ADDENDUM NO. CC-2

March 16, 2026

Lewis Central Community School District
Athletic Building Addition & Renovation
3820 Harry Langdon Blvd, Council Bluffs, IA 51503
BCDM Project No. 5551-05

NOTICE TO BIDDERS: The Project Manual and Drawings for the above-mentioned project are hereby amended as follows:

REFLECTED CEILING PLANS

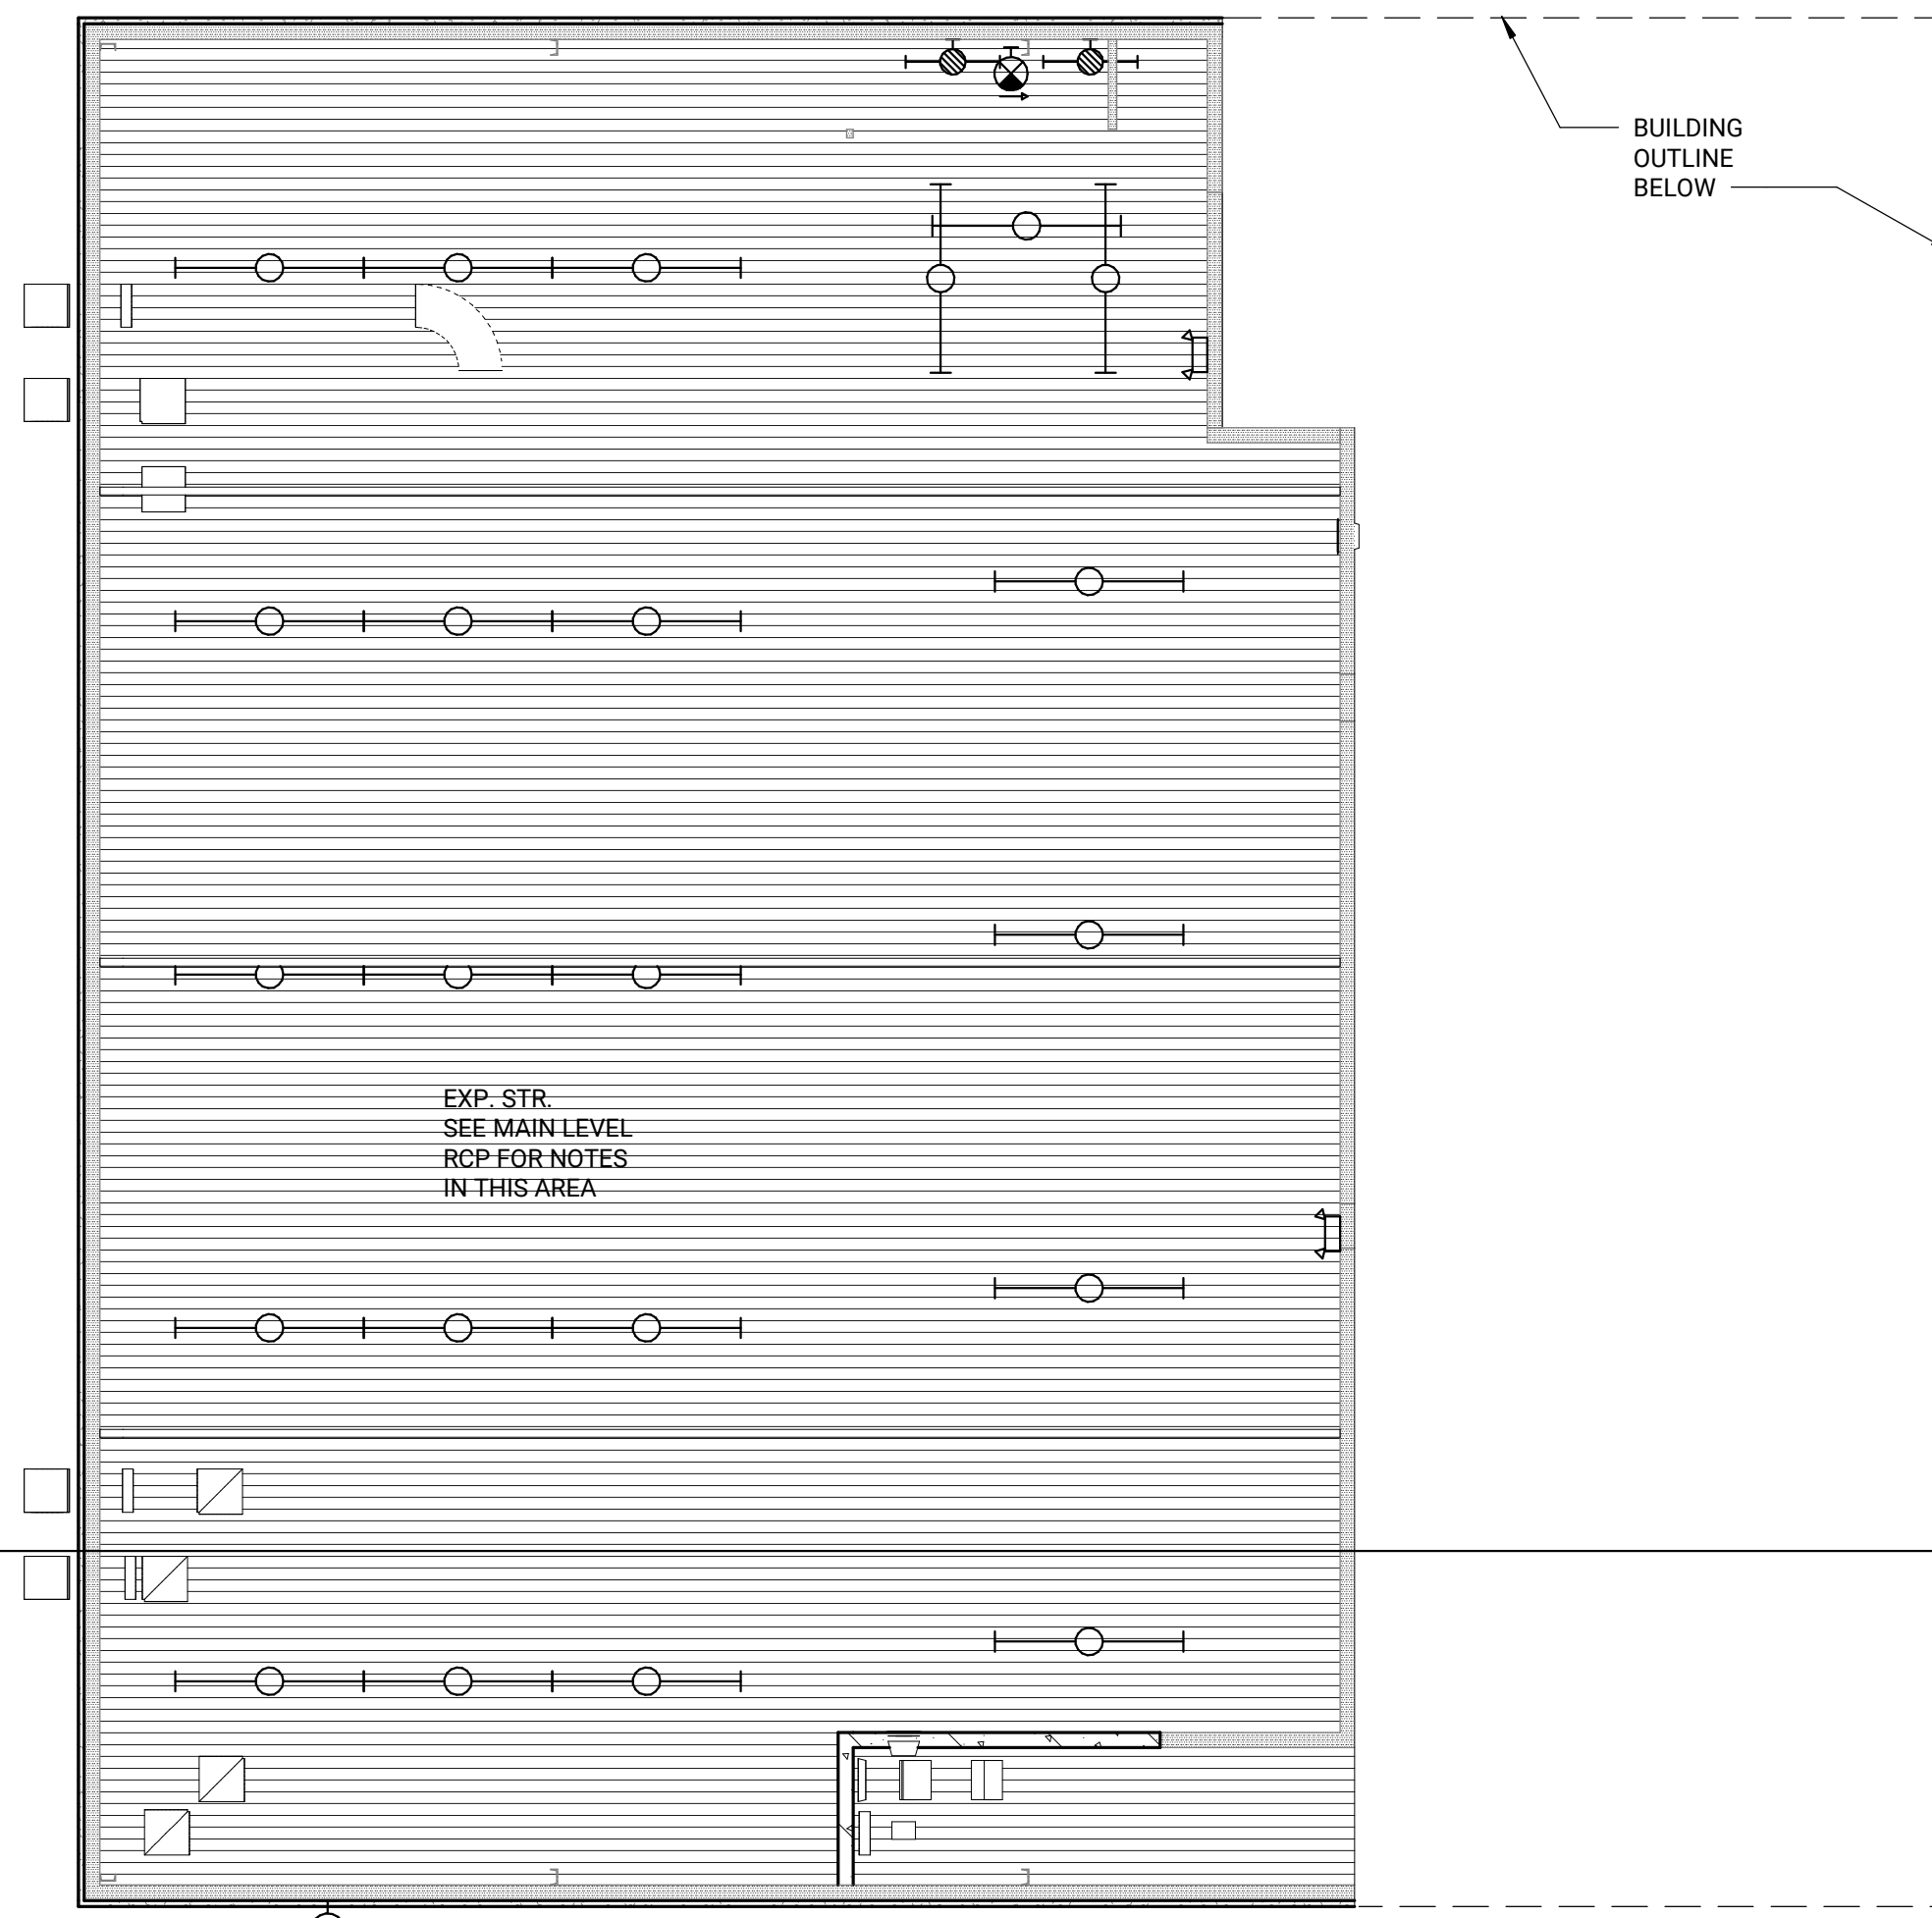
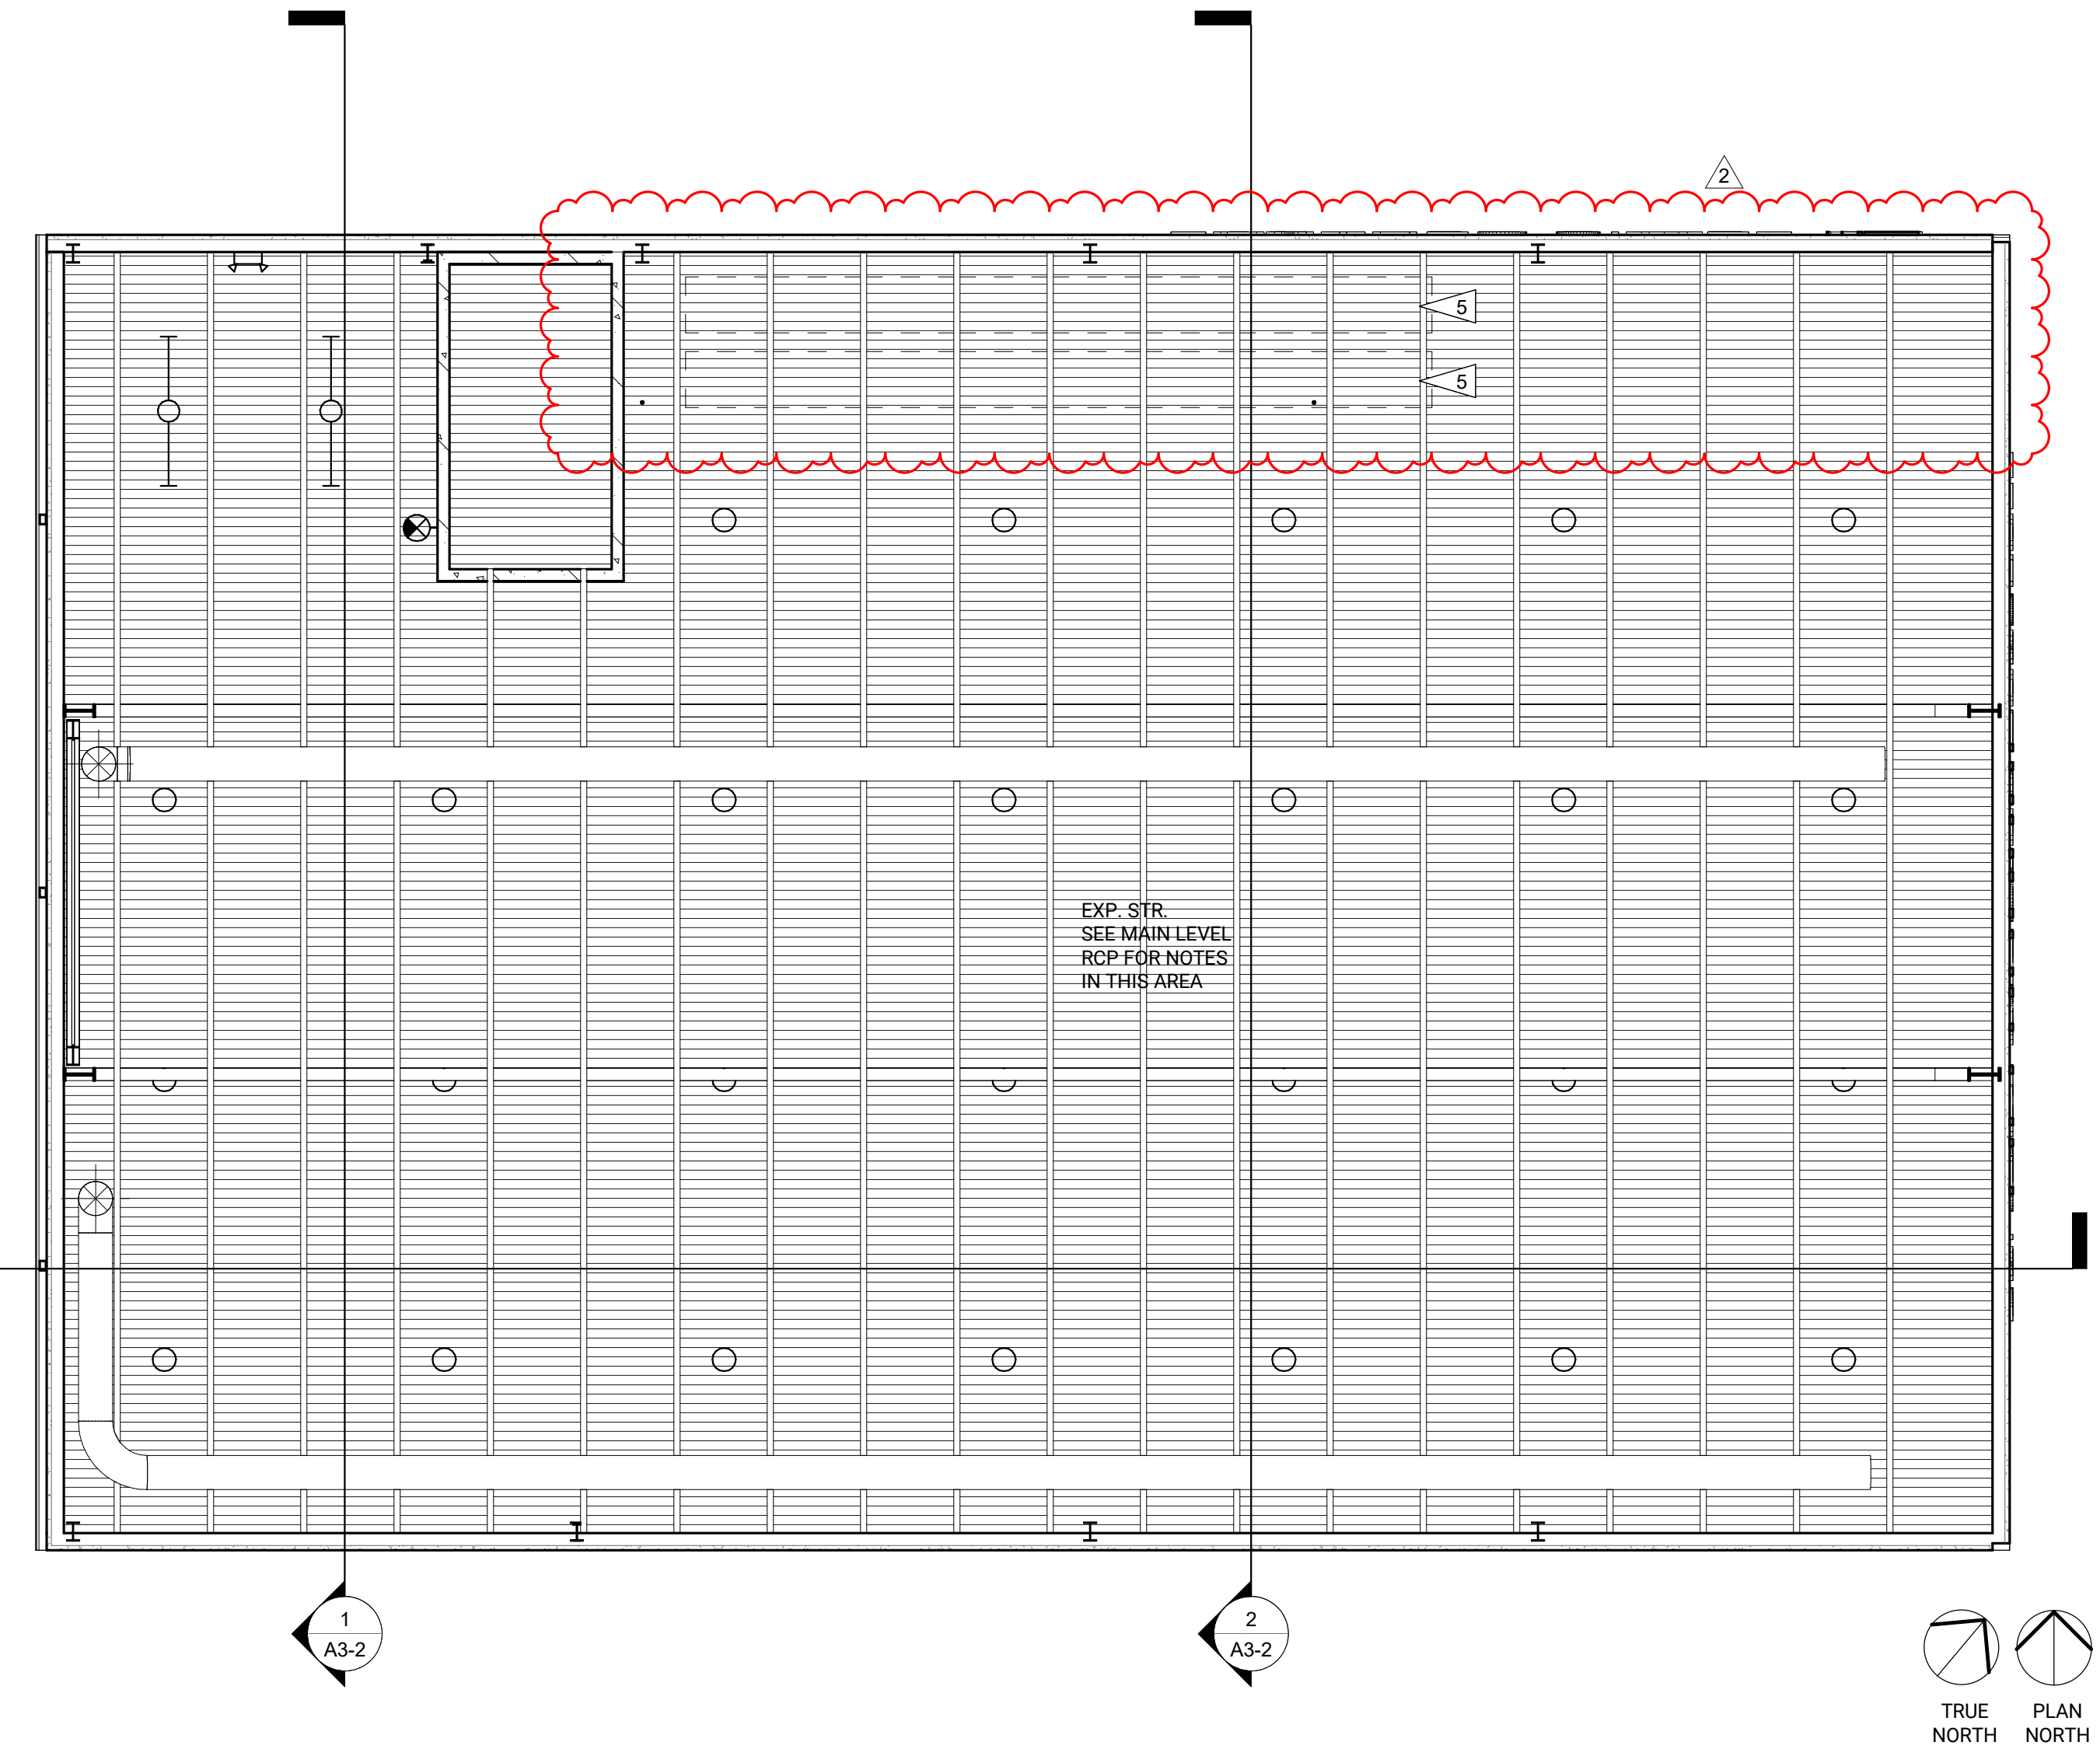
- a. See detail 2/A5-1 on the attached sheet for revisions to the Upper Level Reflected Ceiling Plan.
- b. Reflected Ceiling Plan Flag Notes: Delete flag note 1.
- c. Reflected Ceiling Plan Flag Notes: Add flag note 5 for Wrestling Mat Storage.

1. NOT USED.
2. PROVIDE AND INSTALL ATC HOLD-DOWN CLIPS AT EXTERIOR DOORS AS SHOWN IN THE FOLLOWING HATCH: . SEE SPEC SECTION 09 51 00.
3. PAINT PEMB STEEL MEMBRANE (EXISTING AND NEW) P-4.
4. PAINT PEMB ROOF PURLINS (EXISTING AND NEW) TO MATCH THE INTERIOR COLOR OF THE INSULATED METAL ROOF PANELS, P-3.
5. WRESTLING MAT STORAGE. SEE SPECIFICATION SECTION 11 66 23.56.

STRUCTURAL NOTES & DESIGN DATA

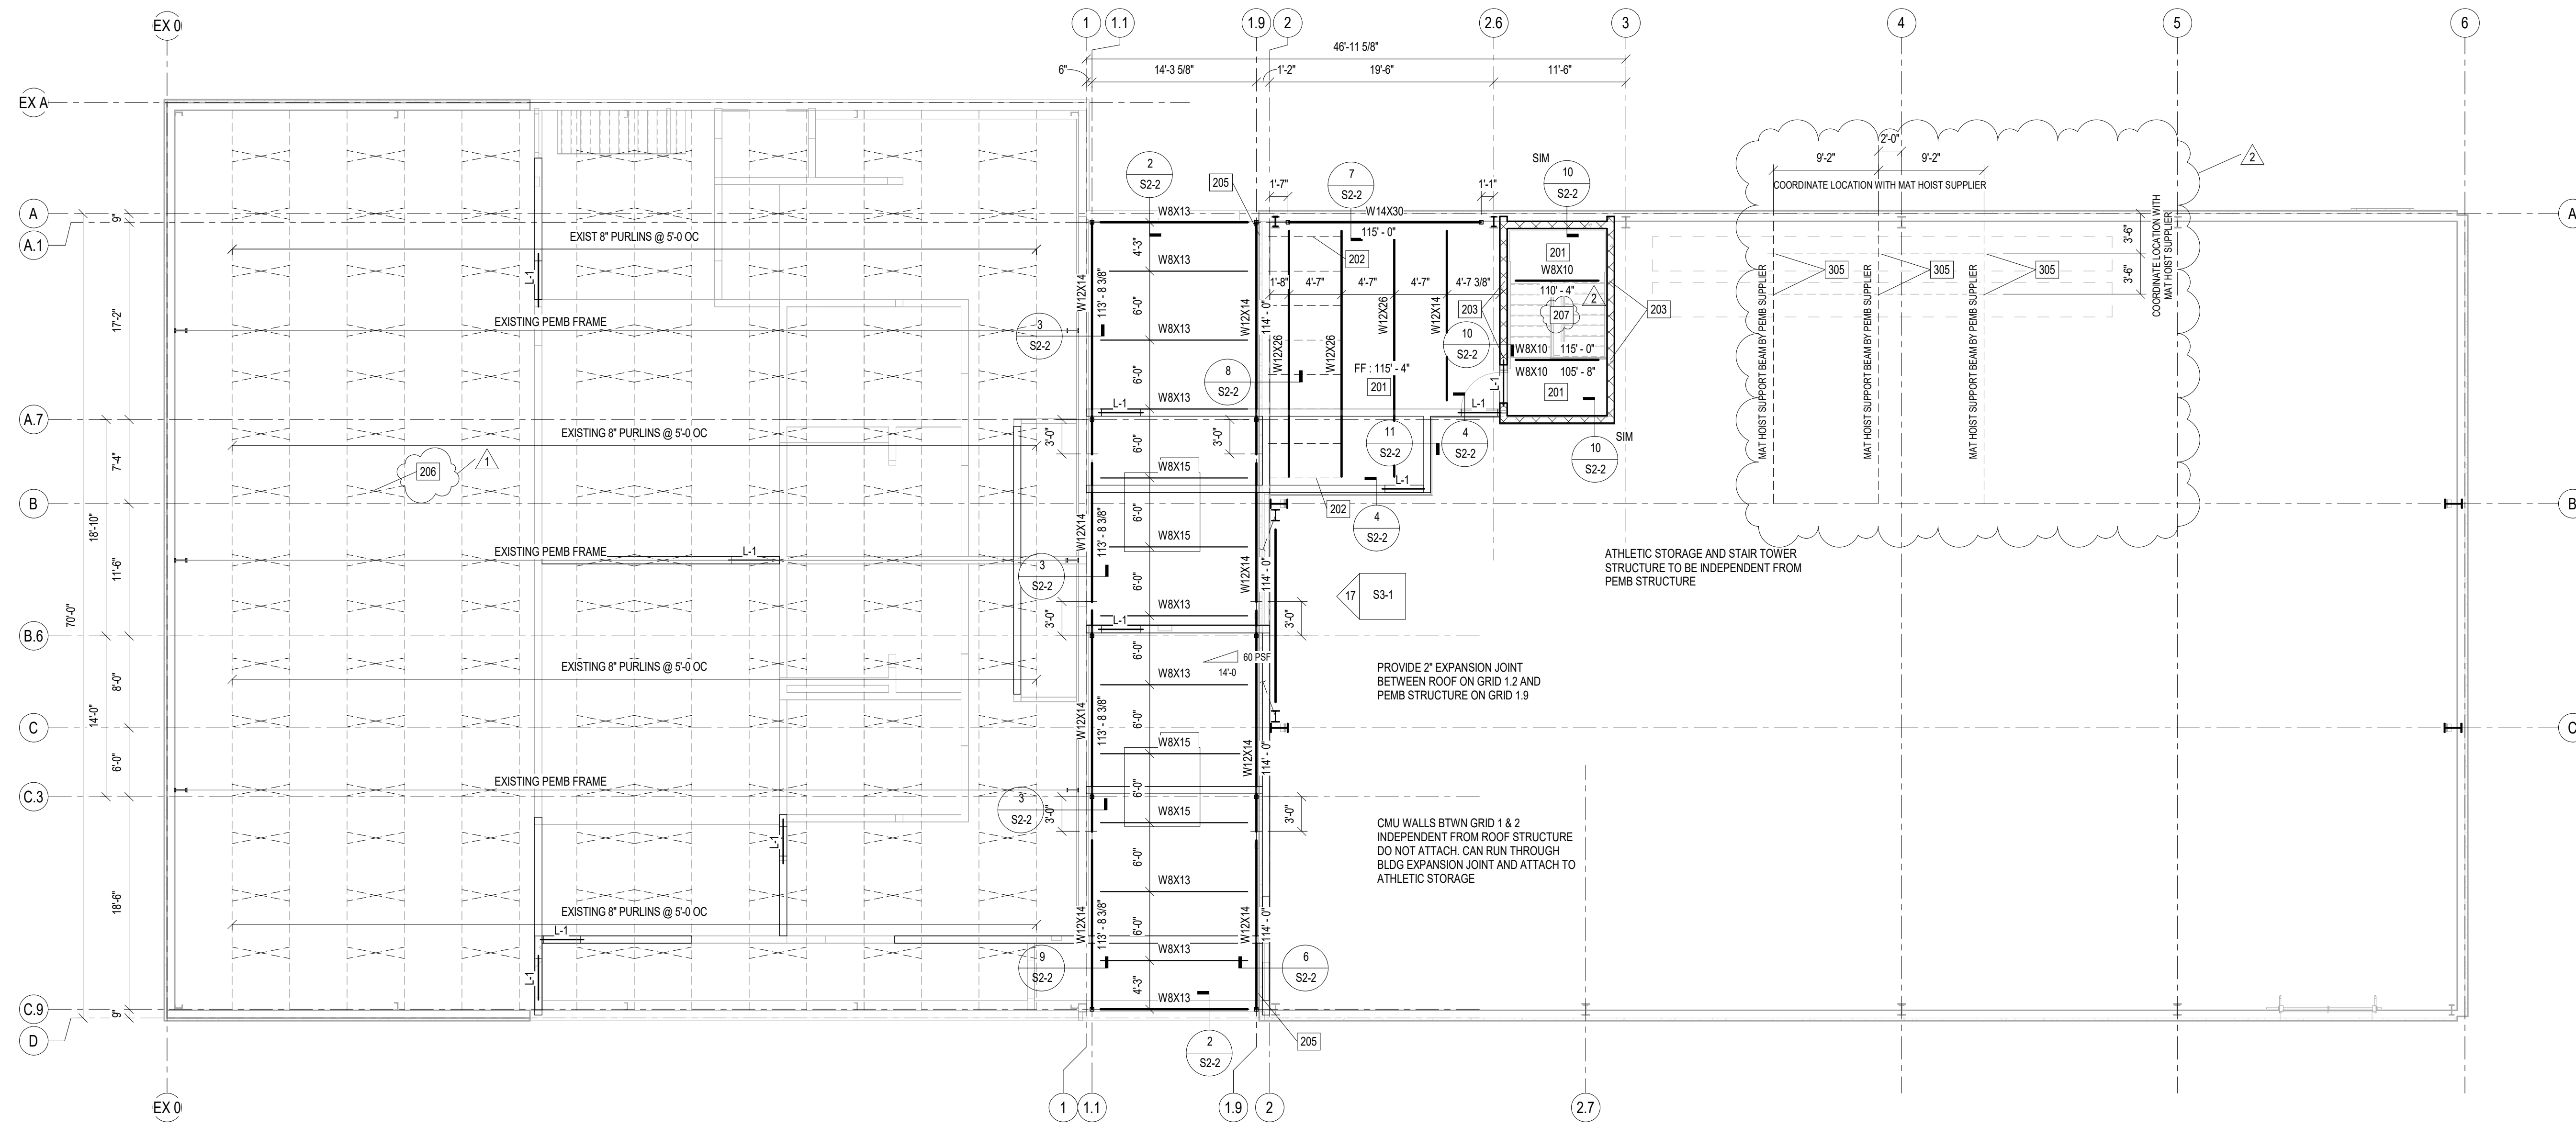
- a. See the attached sheet for updated design loads.

FLAT ROOF SNOW (P _f)	23.1 PSF
MIN FOR DESIGN	25 PSF
SNOW EXPOSURE (C _e)	1.0
THERMAL FACTOR (C _t)	1.0
SLOPE FACTOR (C _s)	1.0
SNOW IMPORTANCE FACTOR (I _s)	1.1
UNBALANCED SNOW LOADS	ASCE 7-16 SECTION 7.6
SNOW DRIFTING	REFER TO PLAN
RAIN INTENSITY:	
60 MIN DURATION	3.81 INHR
15 MIN DURATION	7.21 INHR
FLOOR LIVE LOAD:	
STORAGE MEZZANINE	125 PSF
WIND:	
ULTIMATE WIND SPEED (V)	120 MPH
ASD WIND SPEED (V _{asd})	93 MPH
SERVICE WIND (XX YR MRI)	78 MPH
EXPOSURE	C
INTERNAL PRESSURE COEFFICIENT	0.18
NET UPLIFT ON JOIST	15 PSF
SEISMIC:	
SEISMIC IMPORTANCE FACTOR (I _s)	1.25
SITE CLASS	D
S _e	0.07
S ₁	0.06
S _{0.1}	0.076
S _{0.2}	0.073
SEISMIC DESIGN CATEGORY	B
MATERIAL PROPERTIES:	
REINFORCED CONCRETE:	
28 DAY CONCRETE STRENGTHS (MINIMUM)	f_c f_w
FOOTINGS	4000 PSI 0.48
SLAB ON GRADE	3500 PSI 0.50
SUPPORTED SLABS AND STOOPS	4000 PSI 0.48
WALLS	4000 PSI 0.48
REINFORCING BARS	ASTM A615 GRADE 60
WELDED BARS AND ANCHORS	ASTM A706 GRADE 60
